Application No. 10/621,817

Response dated January 3, 2005

Reply to Office Action of October 1, 2004

Exhibit A (1/Z) JAN 0 3 2005 L

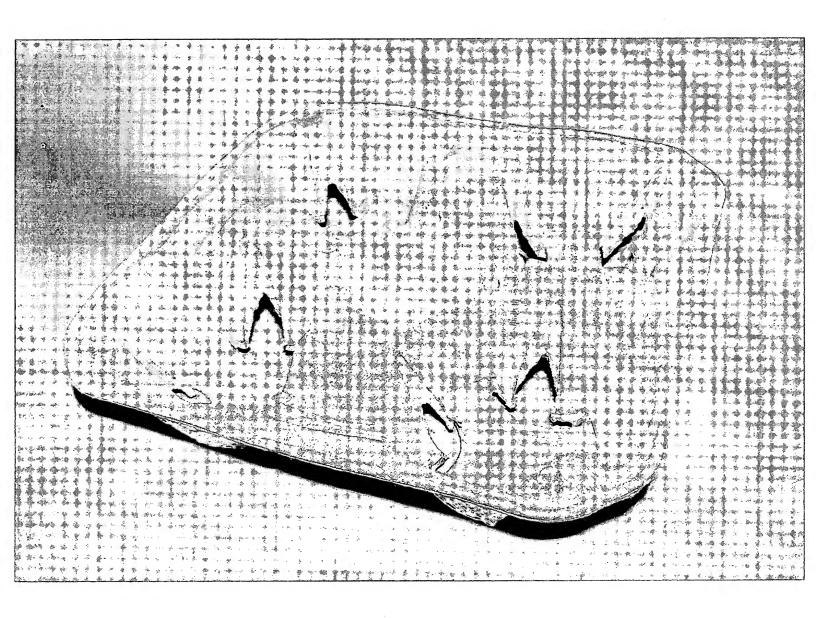
In the Office Action, the Examiner has objected to the drawings. Specifically, the Examiner asserts that the drawings do not clearly show the holding extensions, and alleges that the shape of the holding extensions is indefinite because each holding extension looks slightly different. The Examiner also states that some of the holding extensions look curved while others look straight. Additionally, the Examiner states that the gripping points that have reference numerals appear to come to a point, while the other gripping points look very curved.

Applicant appreciates the observations provided by the Examiner. Applicant notes, however, that the drawings depict one representative embodiment of the present invention, and are provided for purpose of illustration and not limitation. Indeed, the various features referenced by the Examiner need not be identical from one cavity to the next of the present invention. Additionally, Applicant respectfully notes that any perceived distortions suggested by the Examiner in the drawings are likely the result of the views presented. The various aspects of the present invention are clearly defined by the drawings and disclosure, when considered as a whole. For purpose of convenience and comparison, however,

Applicant provides herewith as Exhibit A, two photographs of the representative embodiment

of the cupholder of the present invention.
